ADDENDUM NUMBER ONE

DARLA MOORE SCHOOL OF BUSINESS CONSTRUCTION – BP-3
ENCLOSURE/SITE/MEFP/INTERIOR
UNIVERSITY OF SOUTH CAROLINA
STATE PROJECT NUMBER H27-6069-AC-3

DATE OF ISSUE: June 04, 2012

LEVEL1 AUDITORIUM PERFORMANCE HALL - ACCESSIBLE COMPANION SEATS CLARIFICATION
 REF. DWG # A5112 & A5121
 SHEET TITLE :

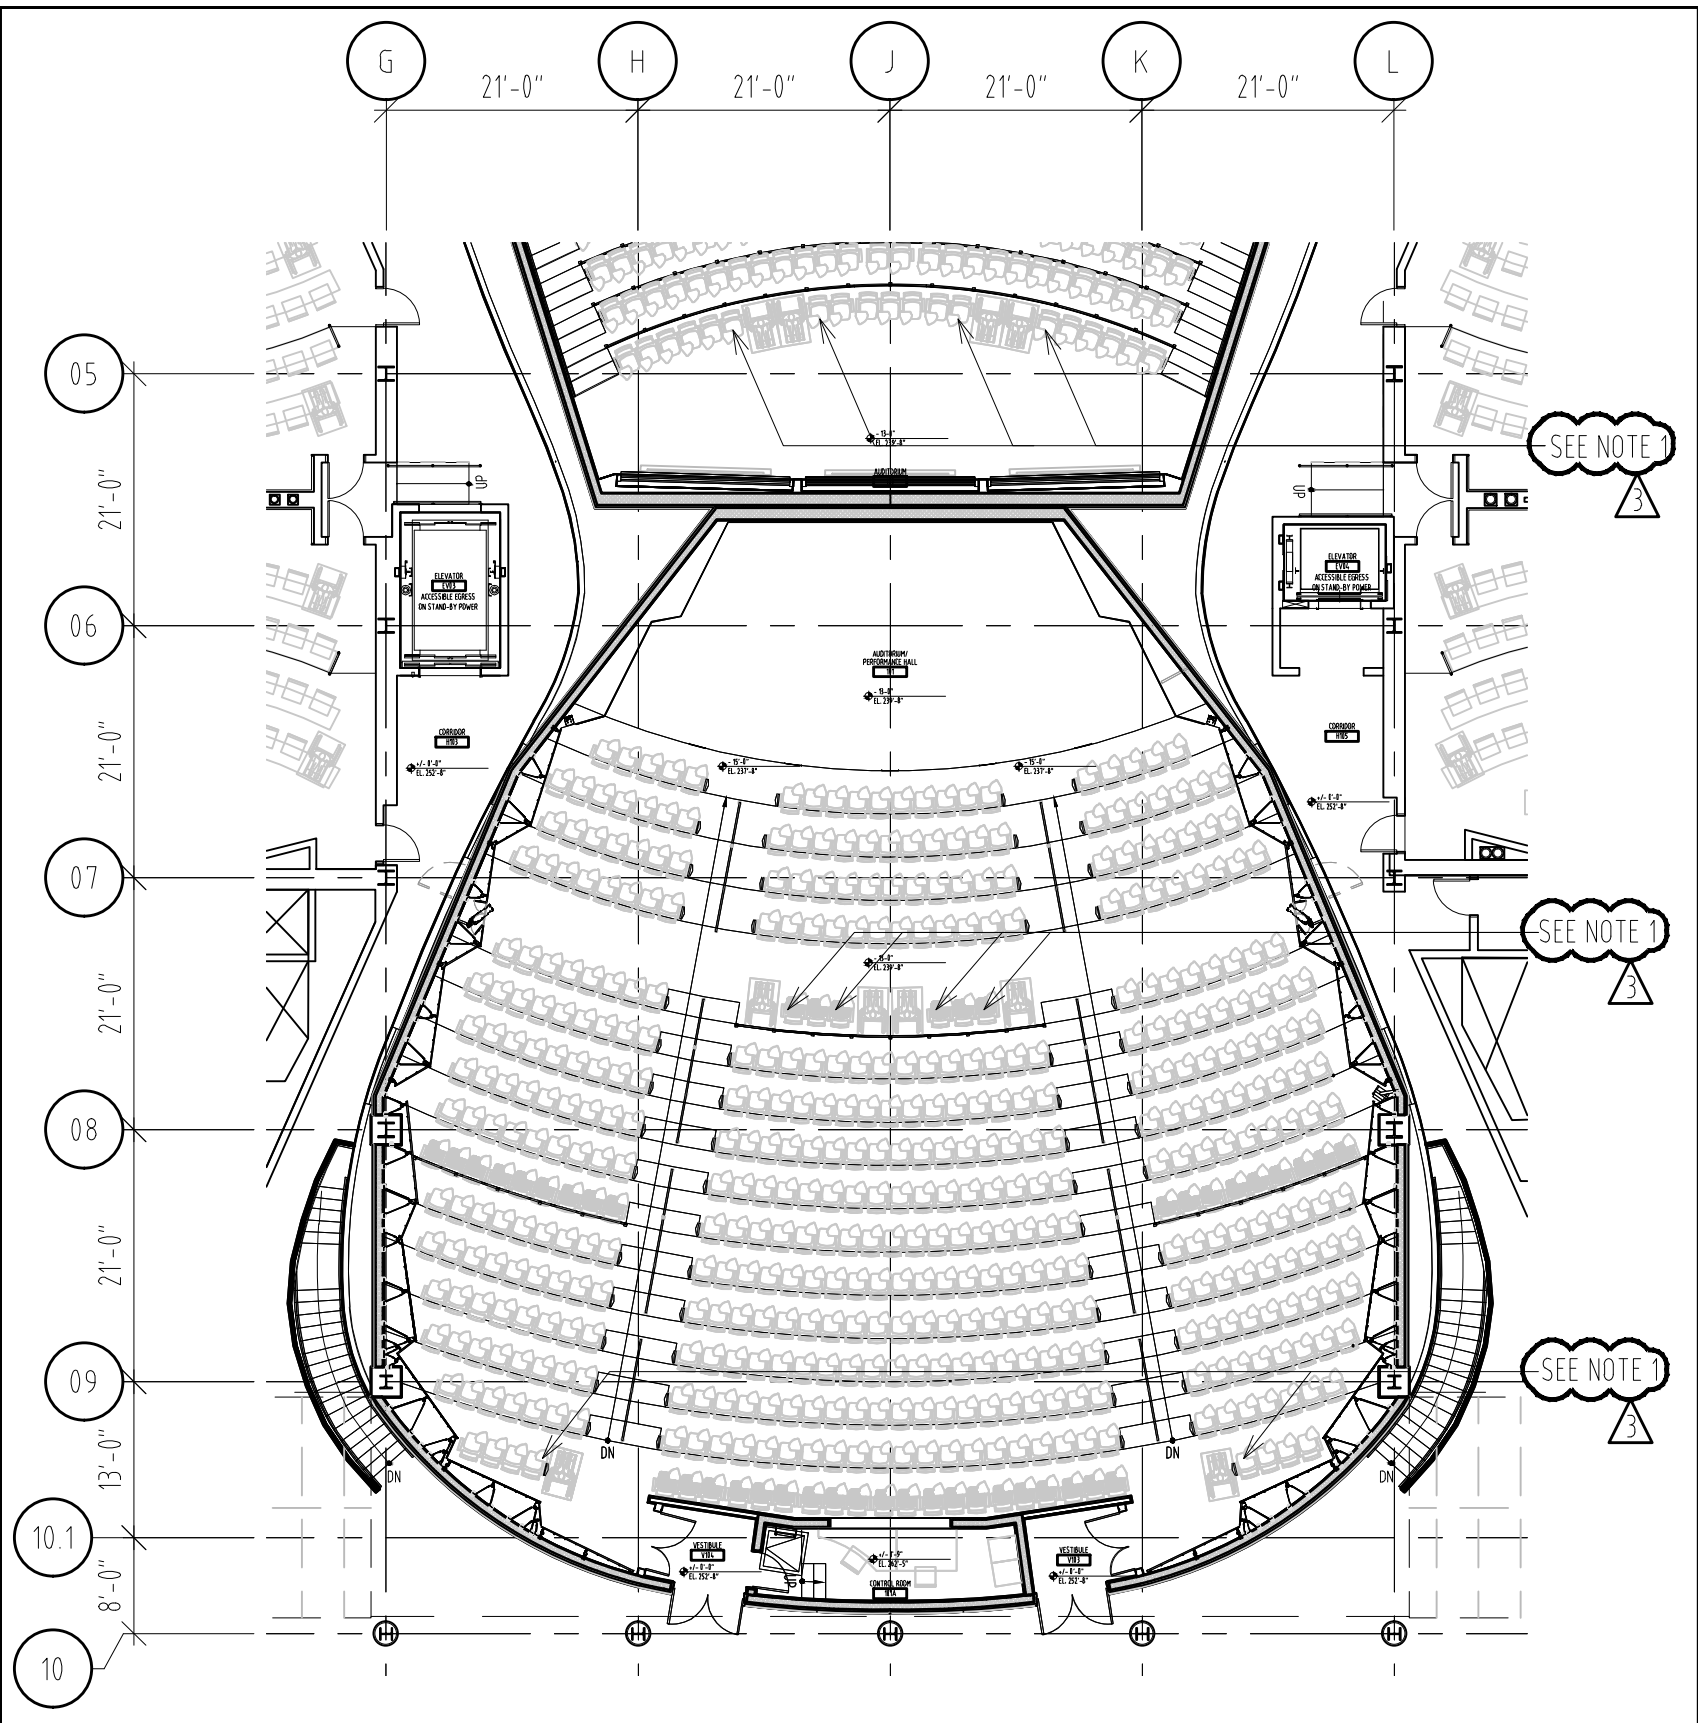
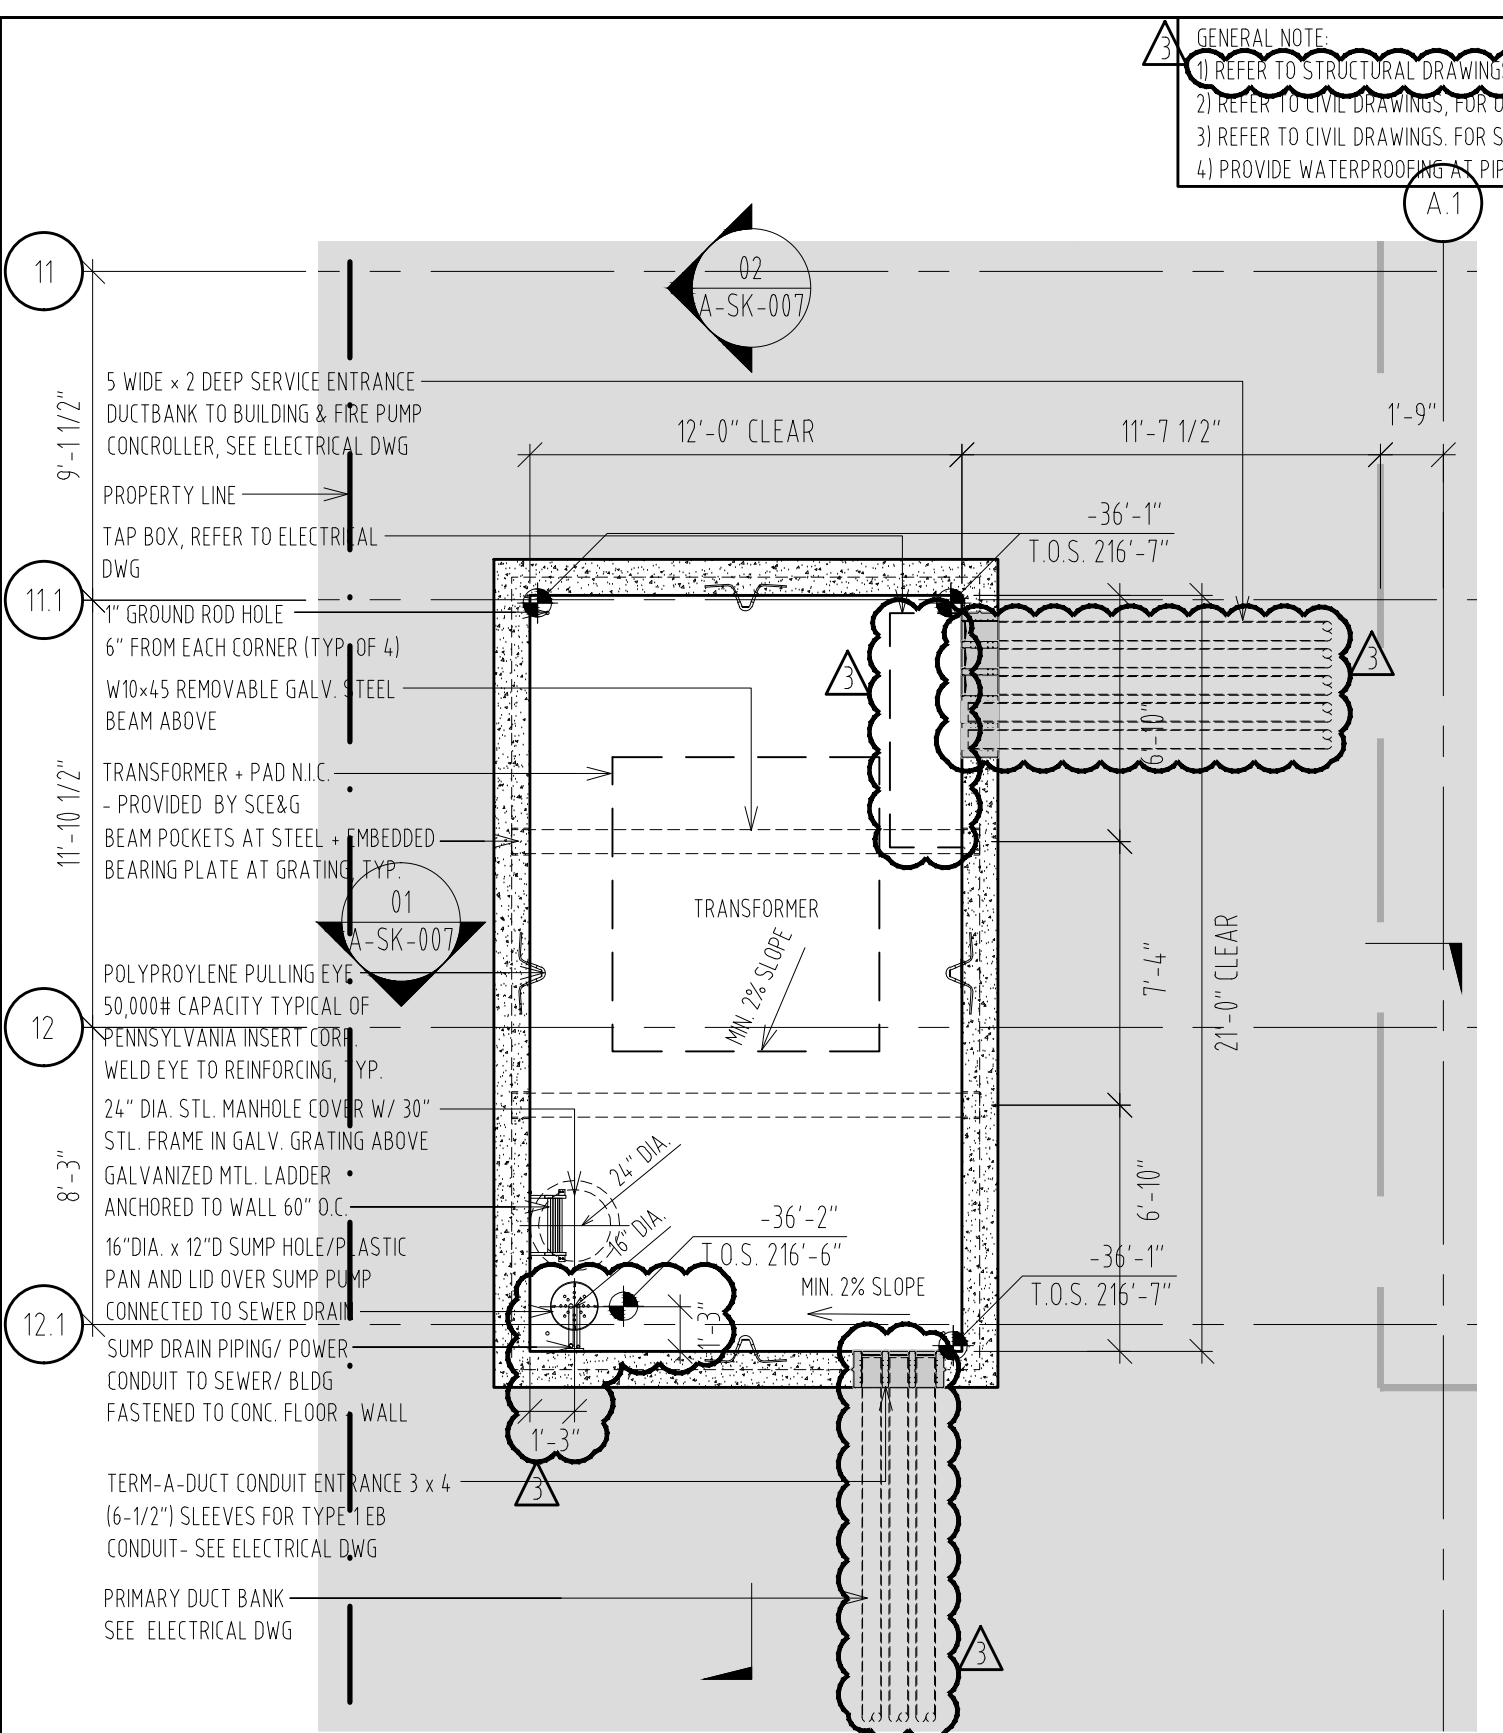
5.	Plan Sheet A5112 & A5121: Refer to attached sketch A-SK-005. Accessible site parking dimension clarifications.
6.	Detail Sheet A0331: Refer to attached sketch A-SK-006 and A-SK-007. Revisions to subgrade electrical transformer vault construction.
